October 20, 2022

***RE: 85 Daniel Street
LU-22-75***

Significant changes from the previous plan are as follows:

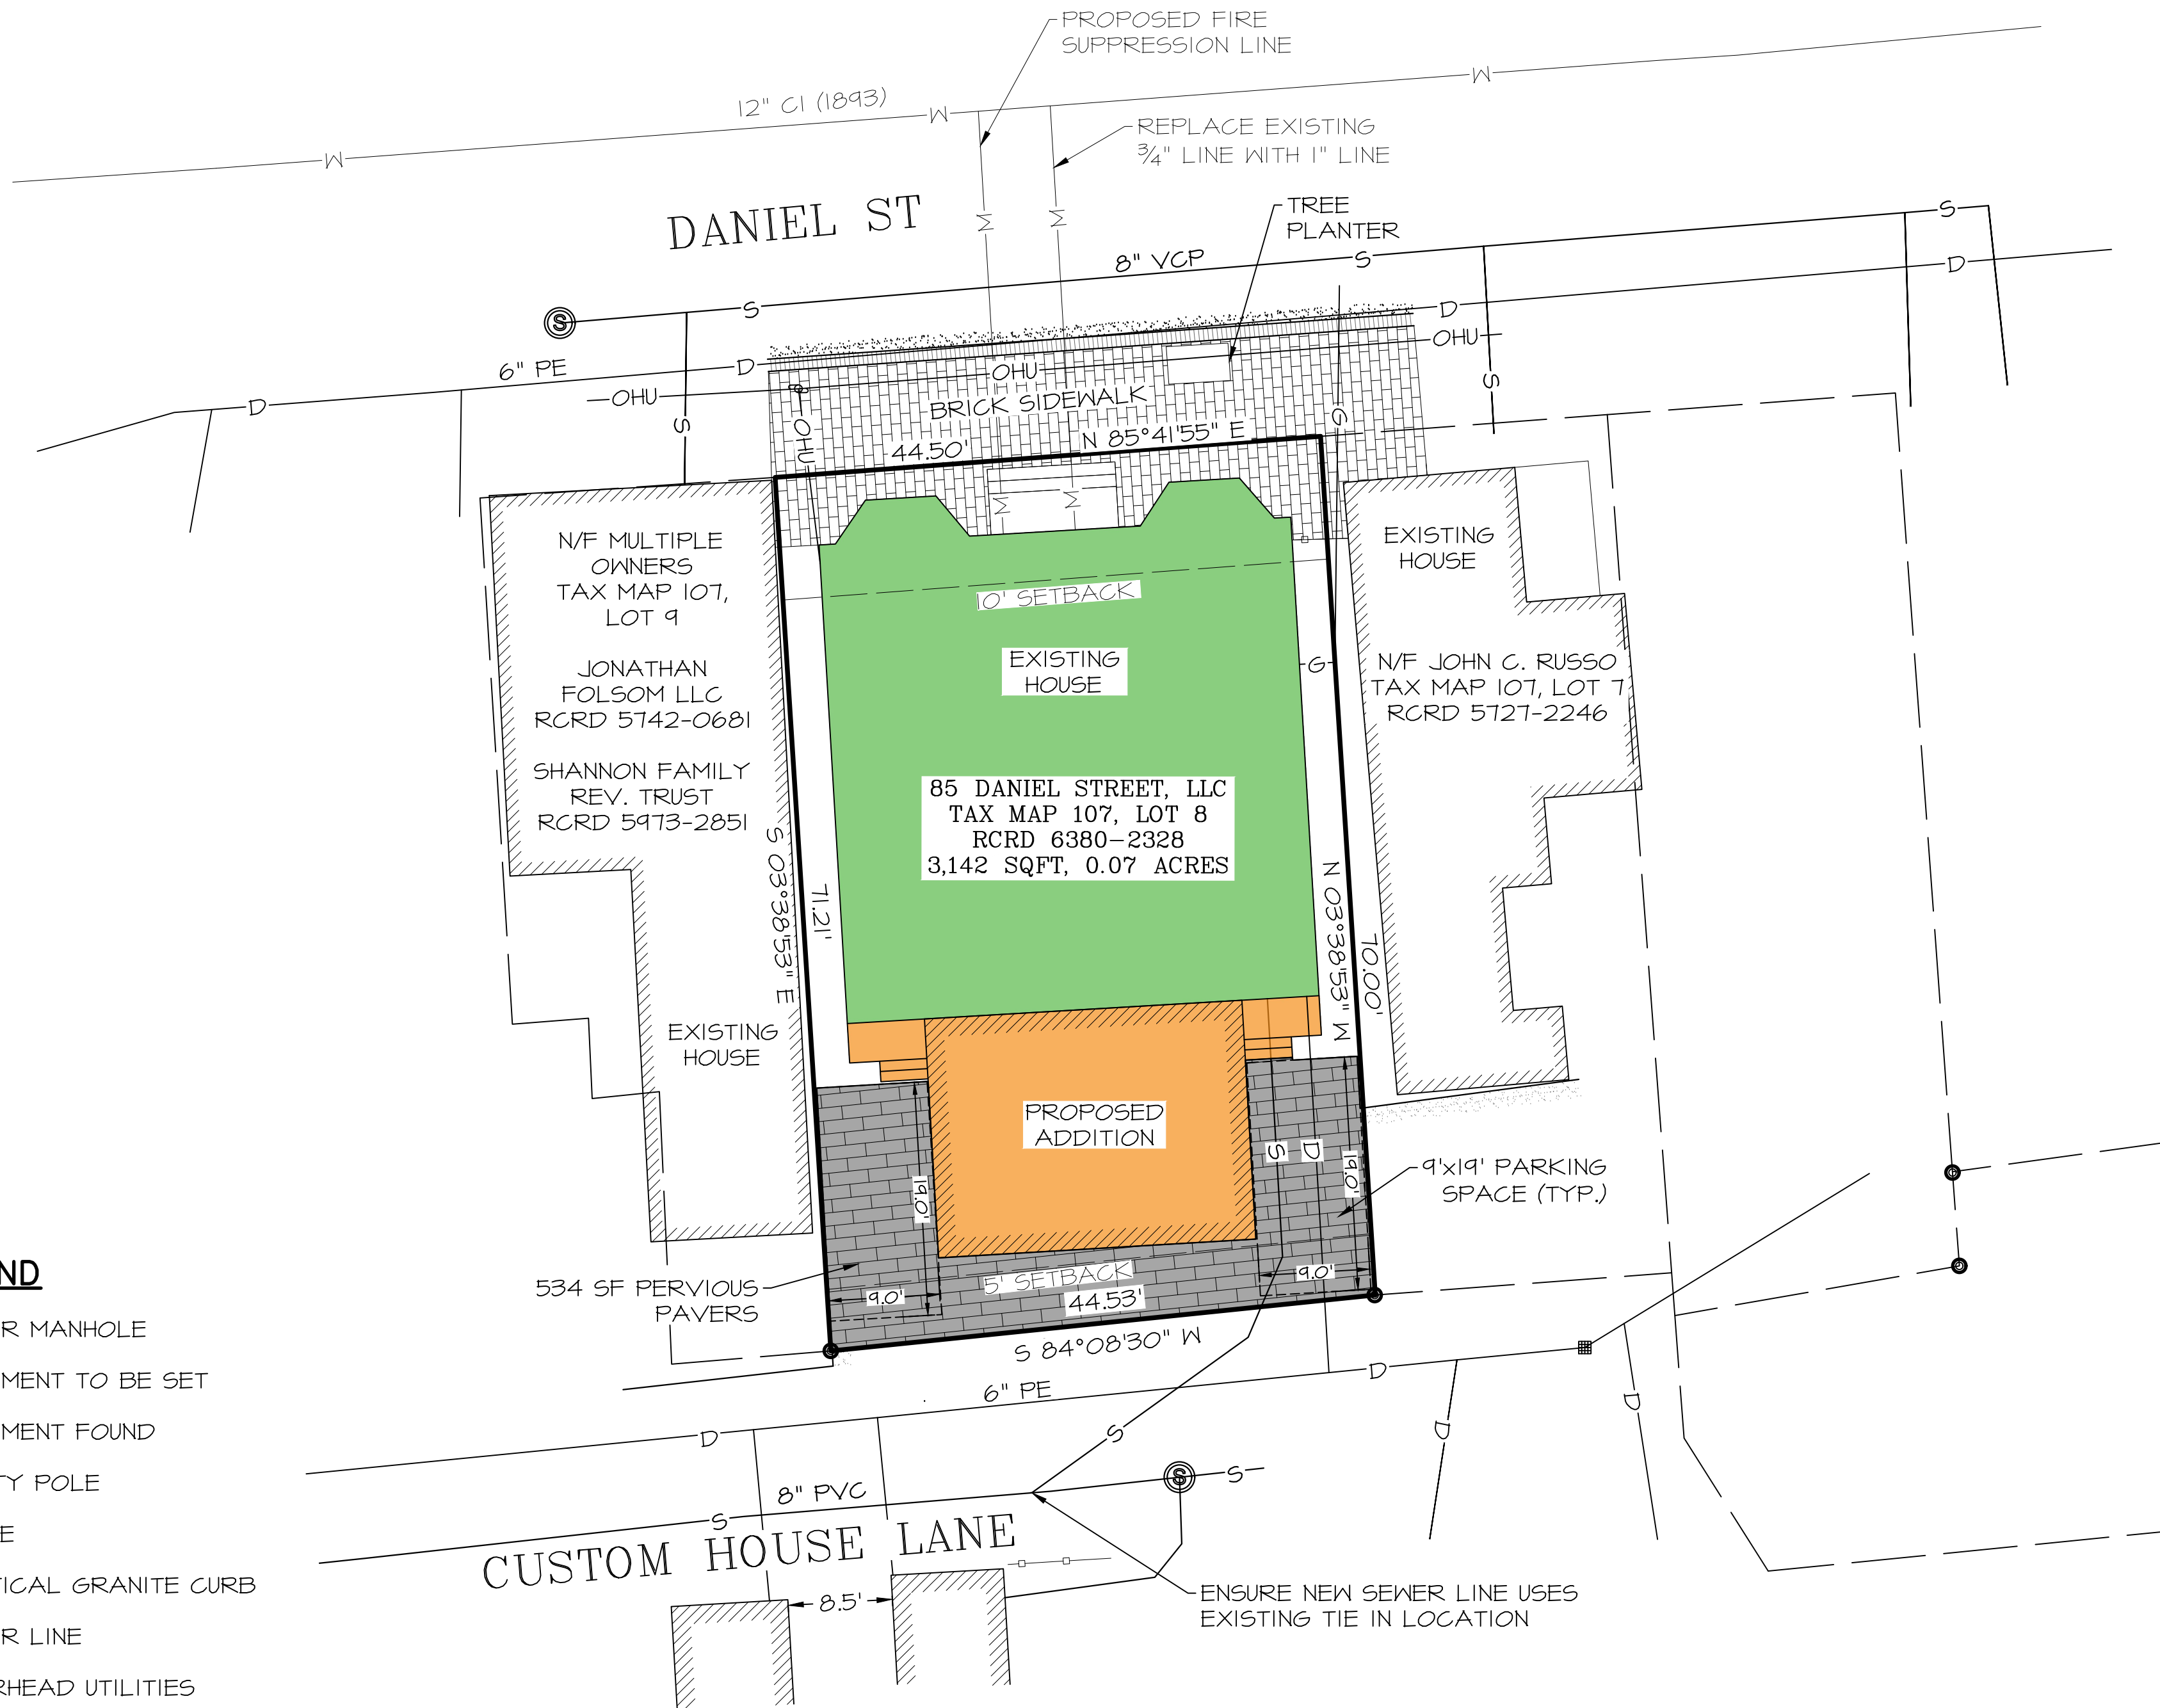
- *Installation of parking lifts in the garage; resulting in a total of 6 off street parking spaces (4 in garage, 2 outside);
- *Removal of designated home office space in the first floor dwellings;
- *Reconfigured sewer to attach to existing junction with main. Added note to plans for sewer department to witness installation and connection to main;
- * $\frac{3}{4}$ " water line to be cut and capped, new 1" line to be installed and secondary service for fire suppression added;
- *Basement egress stairway to comply with NPFA 101, 30.2.4.6.

INSTALLATION OF PARKING LIFTS IN THE GARAGE;
RESULTING IN A TOTAL OF 6 OFF STREET PARKING
SPACES (4 IN GARAGE, 2 OUTSIDE)

- SEWER
- NEW SEWER LINE TO BE INSTALLED, ENSURE NEW
LINE USES EXISTING TIE IN LOCATION

ALL WORK TO BE COORDINATED & APPROVED BY
CITY DPW. DPW TO WITNESS INSTALLATION &
CONNECTION TO MAIN.
